MEMORANDUM

To: Zoning Board of Appeals
From: Kelly Lynema, Assistant Director, Department of Planning and Community Development
cc: Applicant, 10 Sunnyside Avenue
Date: April 23, 2023
RE: 1021-1027 Massachusetts Avenue Comments from Town Boards, Commissions, and Departments

Date: April 10, 2023
To: The Department of Planning and Community Development
From: The Transportation Advisory Committee
Subject: Comments on 10 Sunnyside Ave Comprehensive Permit Application (40B)

To: Zoning Board of Appeals
From: Pdraig Martin, Lead Health Compliance Officer
Date: April 13, 2023
RE: 10 Sunnyside Avenue

C2.00

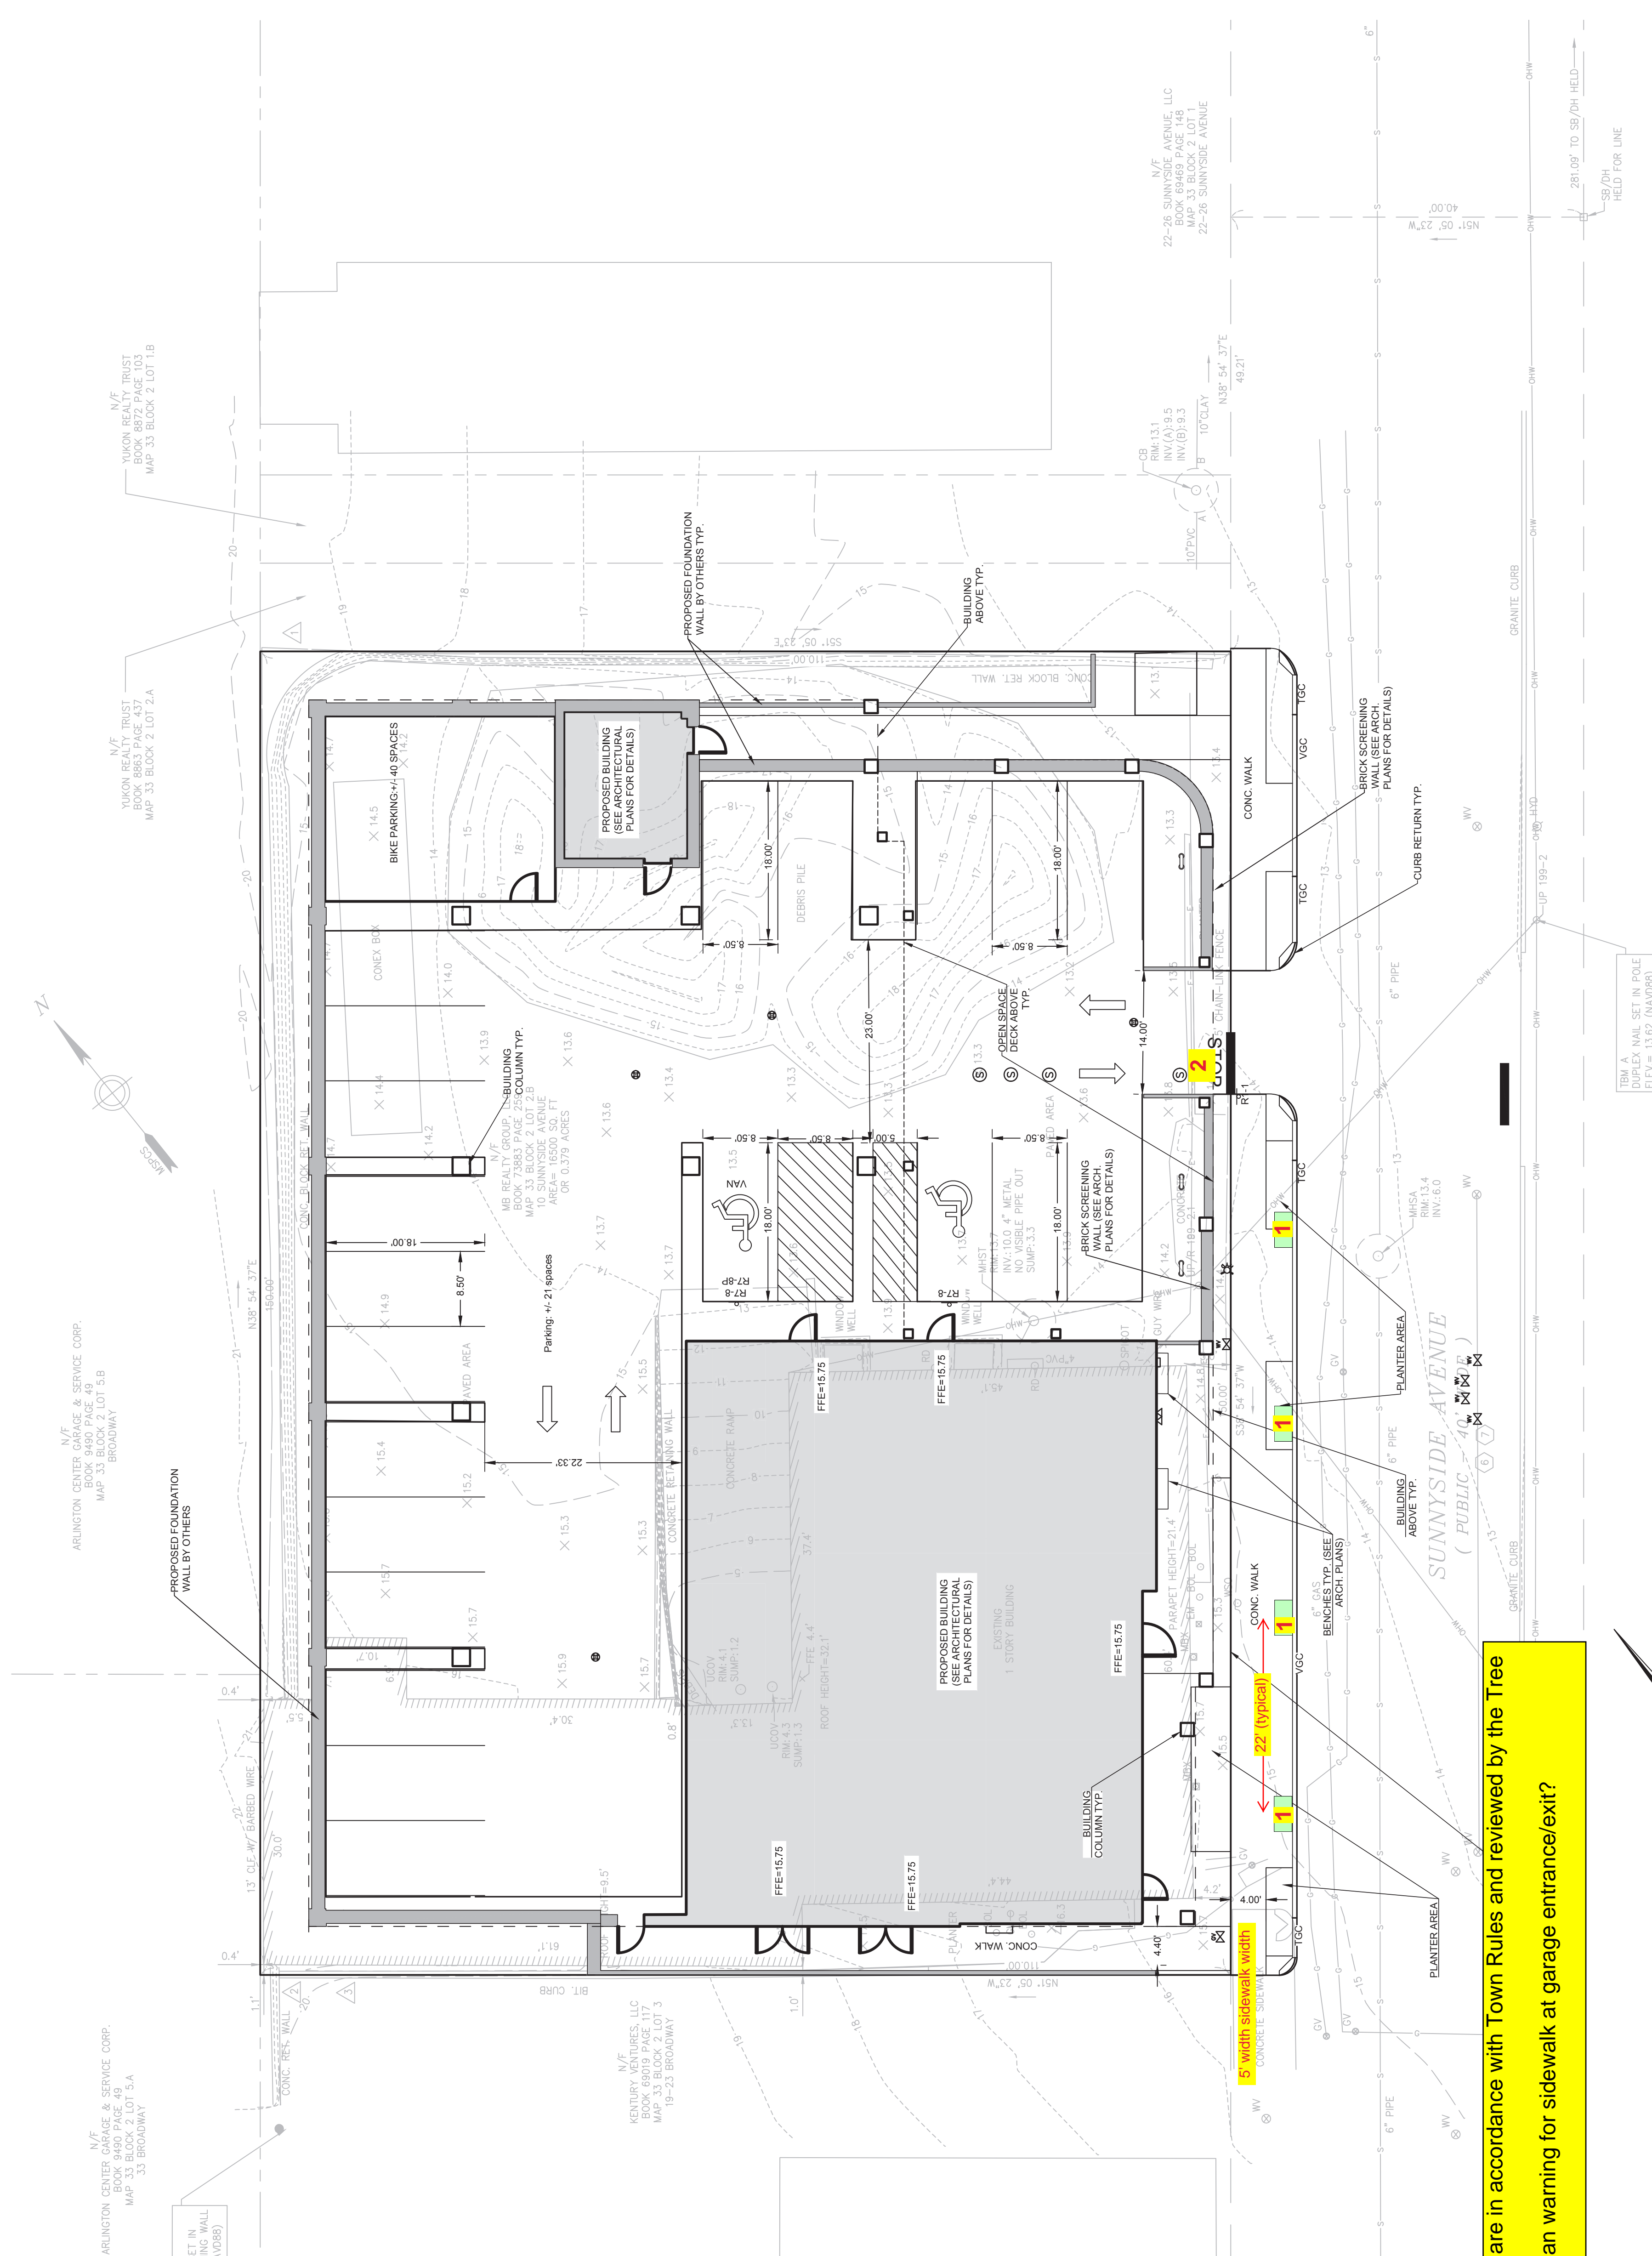
1) Ensure Street Tree Plantings are in accordance with Town Rules and reviewed by the Tree Warden
2) Provide some form of pedestrian warning for sidewalk at garage entrance/exit?

C5.00

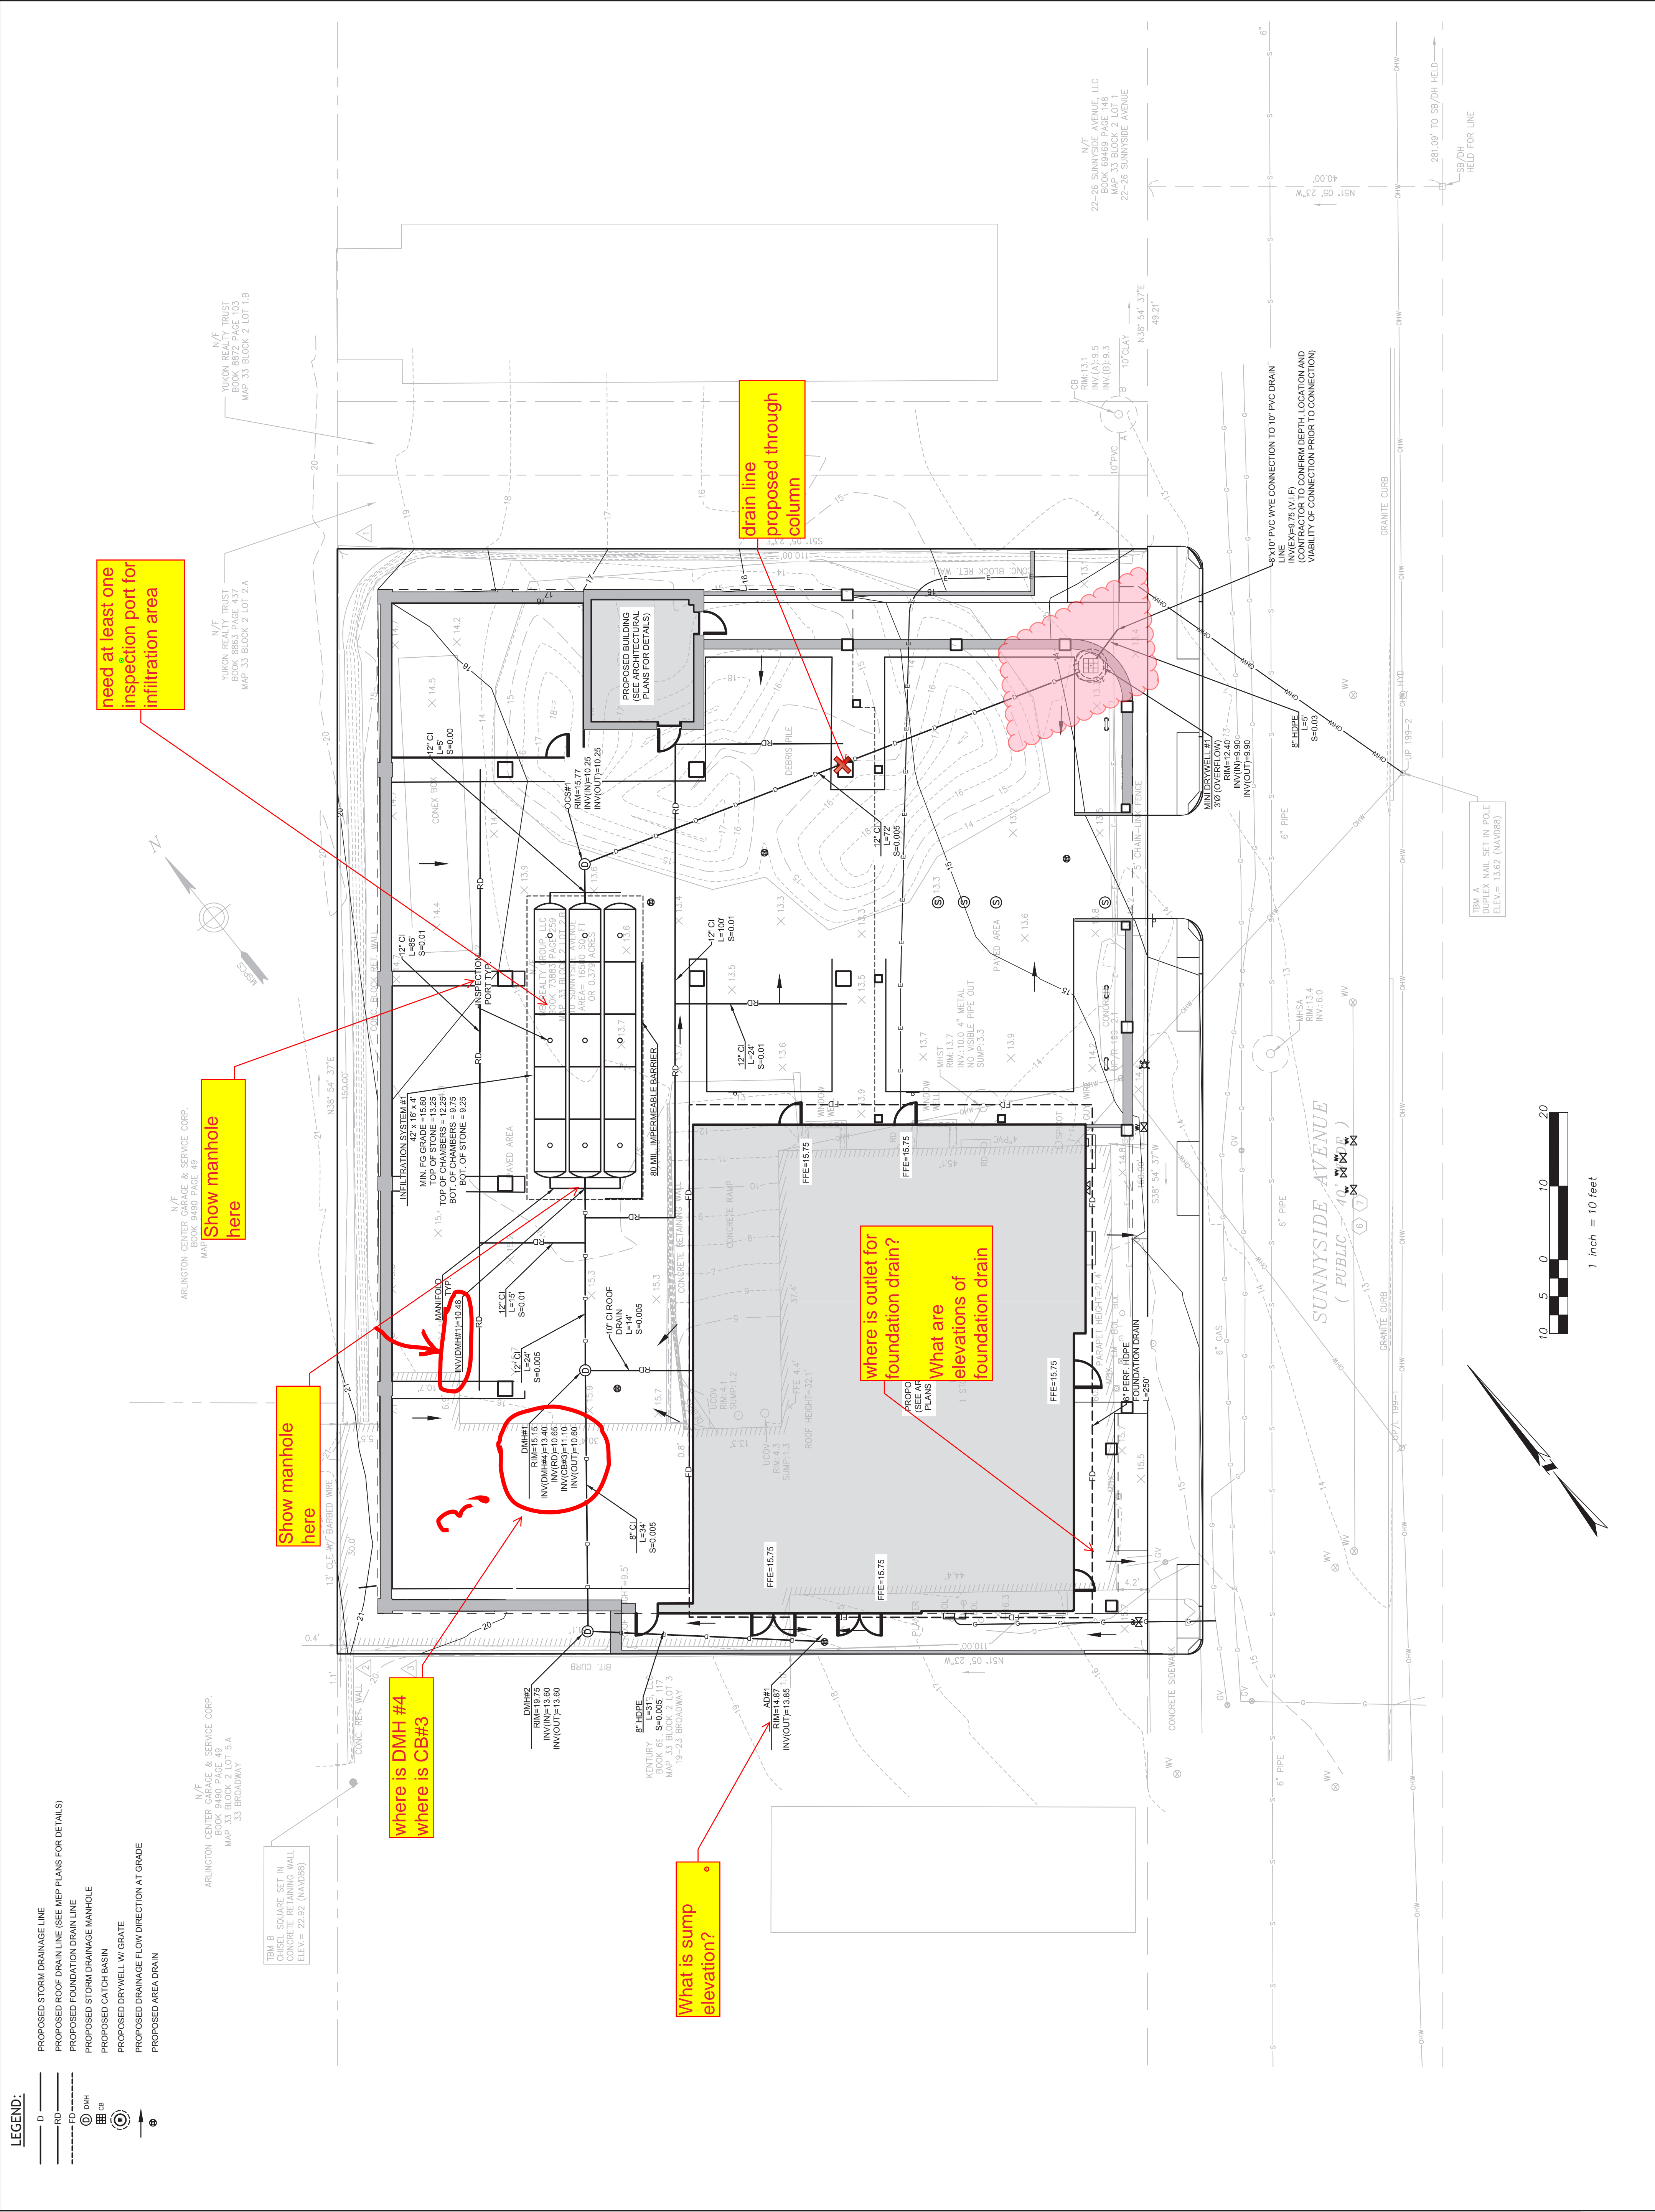
- Sewer line cleanout should be 10 feet from the building.
- Identify manholes on the site plan.
- Identify sump elevation.
- Identify the outlet for the foundation drain and elevations of the foundation drain.
- Call out DMH #4 and CB#3 on the site plan.
- At least one inspection port will be needed for the infiltration area.
